ROUTE NO.	SECTION	COUNTY	TOTAL SHEETS	SHEET NO.
F.A.I. 74	(72-7)R-3	PEORIA	1360	1055
Contract No. 68200

SECTIONS AND DETAILS
RAMP C-3 OVER DRY RUN CREEK
F.A.I. RTE 74(I-74) SECTION (72-7)R-3
PEORIA COUNTY
STA. 10+190.00 TO STA. 10+277.94 (RAMP C-3)
STRUCTURE NUMBER 072-8619 - WALL 18C

ADDENDUM #1, MAY 27 2005

PARAPET JOINT DETAIL

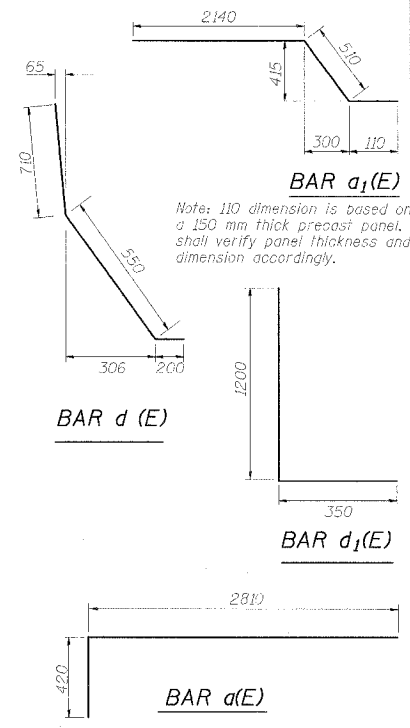
Contraction joints cost included with Concrete Superstructure:

- If Cast-In-Place: joints shall be aluminum sheeted full height, 3 mm Aluminum sheet ASTM B 209M alloy 3003-H14, same dimension as section of parapet.
- If Slip Formed: Joints shall be saw-cut full height.
